VALIDATION OPINION VIETNAM ELECTRICITY (EVN)

VALIDATION OF POST REGISTRATION CHANGES OF THE DONG NAI 4 HYDROPOWER PROJECT

REPORT No. BVC/VIETNAM-PRC/0025/2014

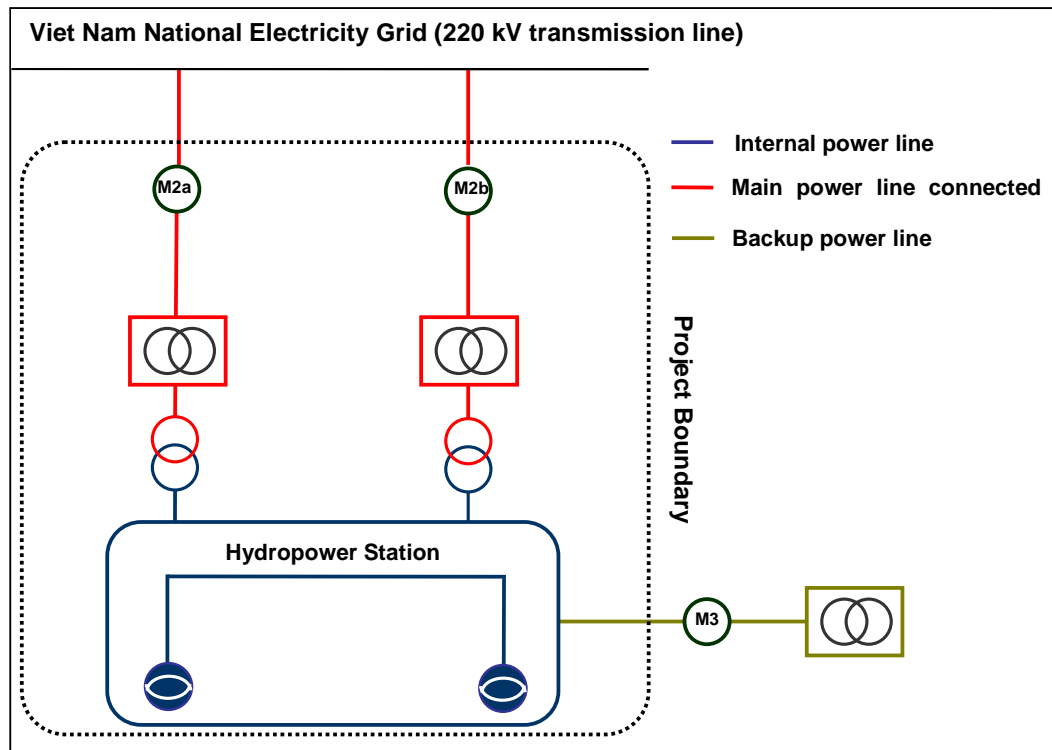
The monitoring system of the project has been shown in the registered PDD as the figure below:

M1x is the main metering equipment located at the point connected to the Grid. It measures the electricity export and import of the project activity which is the basis of billing invoices monthly.

M2x is the backup metering equipment installed alongside the main meter at the substation. It is used to compare with the records from the main meter, and used as record source in case the main meter fails.

M3 is the metering equipment installed in backup power line supplying the power to the project activity to maintain or repair equipment. And M3 meter is owned by Dak Nong Power Company (under EVN) who is selling the electricity for Dong Nai 4 Hydropower Plant for internal consumption via 22 kV line. Hence, M3 is managed and calibrated according EVN's schedule without any involvements of Project participant.

Corresponding to the paragraph 298 of VVS version 07, the different in meters' accuracy class between the registered monitoring plan and the temporary situation will cause the deviation on the calculation of the emissions reductions for the proposed project activity.

The deviation happens due to the accuracy level required by the registered monitoring plan is 0.2s while the temporary installed equipment has lower accuracy level (which is 0.5s). Therefore, the measured values of exported and imported electricity are adjusted using a discount factors as follows as per paragraph 4 of Appendix 1 of Project Standard **/Ref-02/**:

- Adjusted value for exported electricity = measured value – (measured value x 0.003), since this parameter is used for calculating baseline GHG emissions following paragraph 4(a), footnote 2 of Appendix 1 of the Project Standard **/Ref-02/**.
- Adjusted value for imported electricity = measured value + (measured value x 0.003), since the electricity imported from the Grid is consumed for internal using purposes of the project, hence this parameter is considered as a project emission and needs to be applied the adjustment factor to calculate emission reductions as per paragraph 4(b), footnote 3 of Appendix 1 of the Project Standard **/Ref-02/**.

The verification team has checked and found the adjustment factors been applied by the project participant for calculating the emission reductions with a conservative approach as per paragraph 270 & 298 of VVS version 07 **/Ref-01/**. Detail of the calculation of emission reductions can be found as follows:
